File **PPP-1996-048**

Name: **Moonrise East / Sunset Village – NE Corner of 25 ½ Road / F ¾ Road**

File No. FPP 96-48

COMPOSITE DRAWING

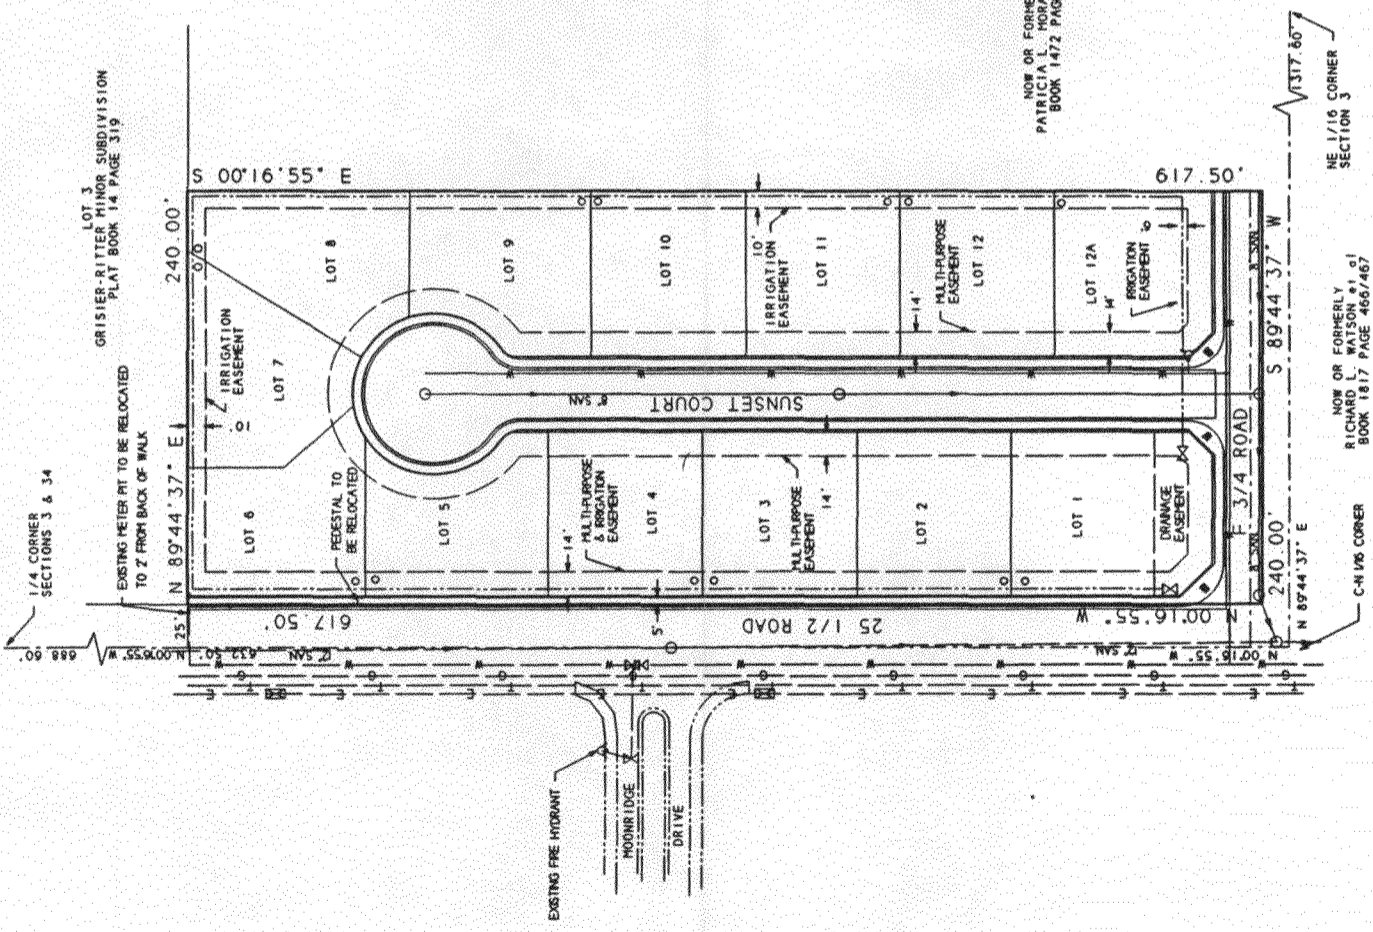
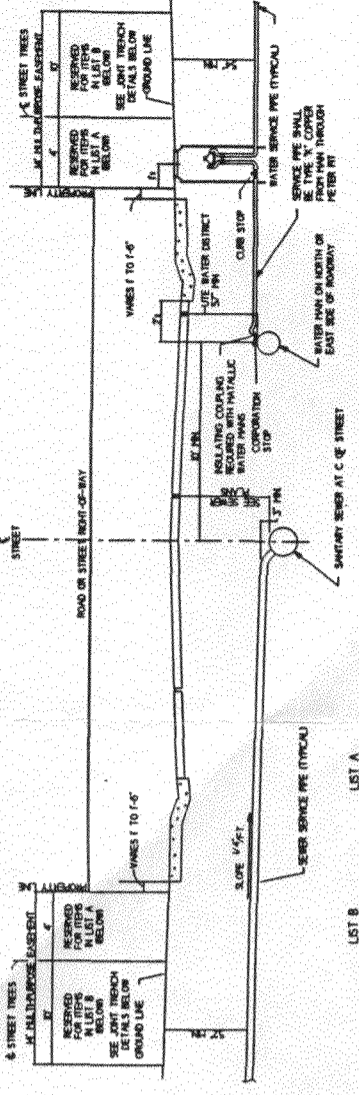
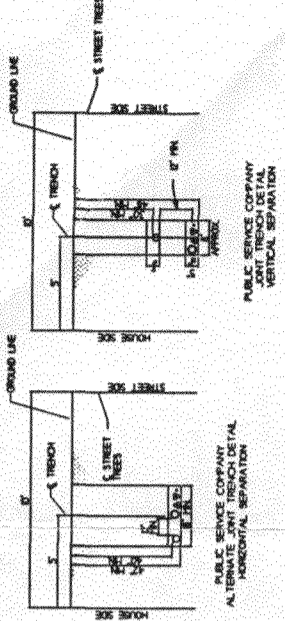
10. Sheet 1 of 2: The grade shown on F 3/4 Road exceeds the maximum 4% allowed in unsignalized intersections as per City Transportation Engineering Design Standards section 6.2.2, page 27.

11. The profile for F 3/4 Road does not show where an existing irrigation pipe crosses 25 1/2 Road (indicated on 25 1/2 Road profile).
12. The portion of irrigation pipe shown on the 25 1/2 Road profile which crosses under F 3/4 Road must be constructed with C-900 pipe or equivalent because it has less than 4 feet of cover. Please note, if cover is 18" or less, new City specifications require backfill with flowable fill.

13. Street sheet 2 of 2: Vertical curb is required on F 3/4 Road.
14. Grading and Drainage plan: As noted above, C-900 pipe or equivalent is required under the F 3/4 Roadway.

15. The plan still shows what appears to be an existing ditch under the proposed F 3/4 Road. What is it and what will happen to it?
16. The property owners to the south are currently piping the existing irrigation ditch. The drainage plan needs to show that and how tie-ins will be made.

17. What is the L-shaped structure shown in the detention basin? Please label and size it (width, length, material).
18. I do not understand how the outlet structure will work in this pond. Are you intending to tie into the irrigation pipe? If so, a better detail is required showing a manhole. The previously submitted single sheet of calculations does not explain how the structure works or what it discharges to. Please be clear in the narrative of the complete final drainage report.

19. The irrigation waste ditch plan and profile does not include some essentials such as a north arrow and scale. Please refer to SSID IS-30 for a checklist for a similar drawing.

20. The plan view for the irrigation pipe appears as though the pipe terminates under the pavement of F 3/4 Road. Please show the tie-in detail with the pipe currently being installed by adjacent property owners.
